RE: 16668 Shannon Road

I reviewed the drawings, and evaluated the site context. My comments and recommendations are as follows:

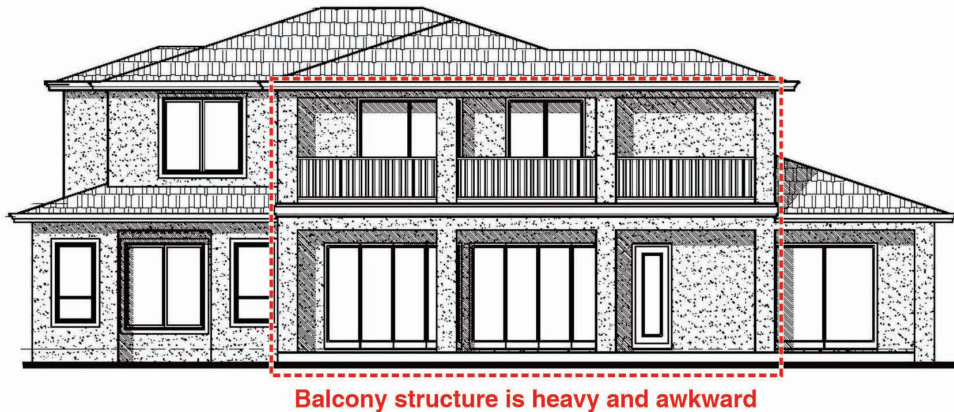
1. The second floor bay window on the front facade is awkward and is fighting the entry for attention.
2. The differing first floor eave heights create awkward transition conditions, and are not typical of the proposed architectural style.

1. Simplify the front facade by eliminating the second floor bay window and match other rectangular windows.
2. Raise the first floor eave on the front and right side elevation to provide a common eave line height.

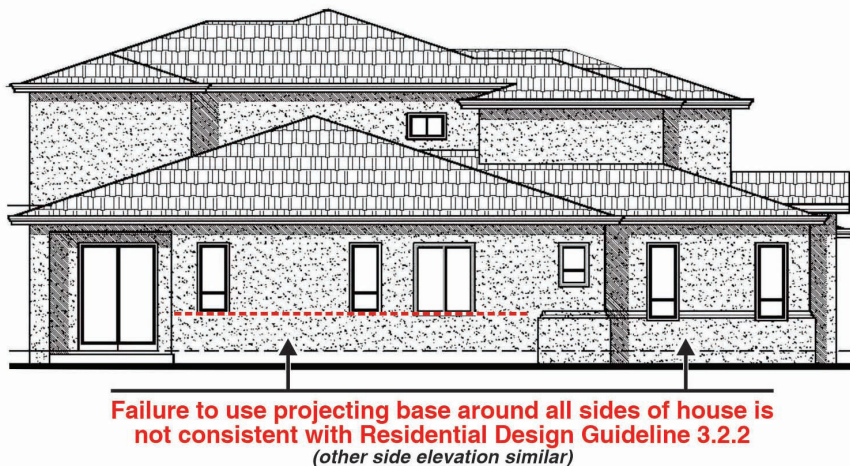
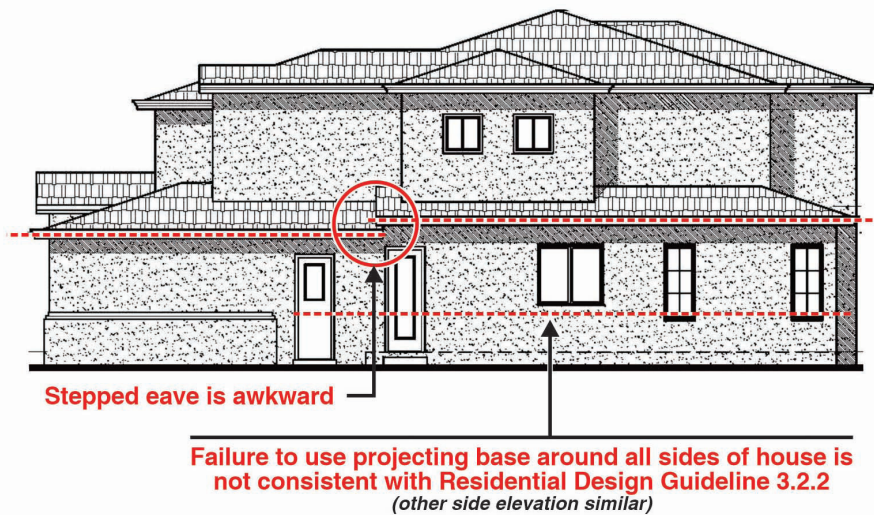
3. The covered terrace and balcony on the rear facade is heavy and awkward.

4. The articulated projecting base is appropriate to the architectural style, but does not carry around the sides and rear of the home which would not be consistent with Residential Design Guideline 3.2.2.

3. Refine the rear elevation by using wood columns, beams, bases and column caps in lieu of the proposed stucco. Also, open up the sides of the second floor balcony.

2.4.4 Limit the use of circular driveways

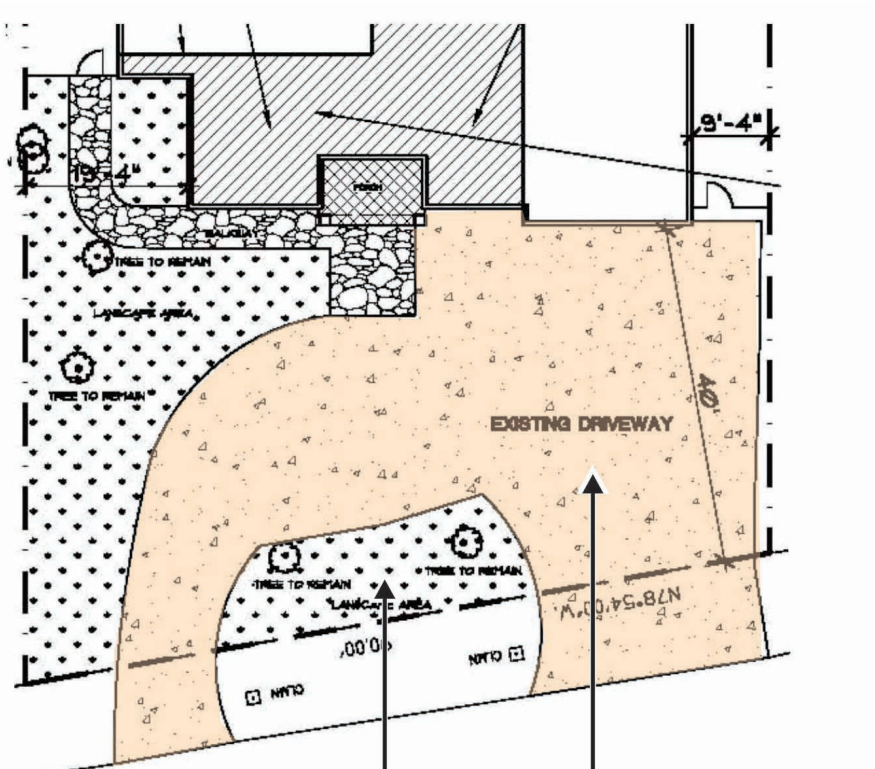
5. The circular driveway without substantial landscape buffering and modular paving would not be consistent with Residential Design Guideline 2.4.4.

Circular driveways without substantial landscaping and modular paving is not consistent with Residential Design Guideline 2.4.4

6. Provide additional buffer landscaping, retain the existing landscape area along the right property line, and use modular driveway paving consistent with Residential Design Guideline 2.2.4. See photo of previous landscaping below
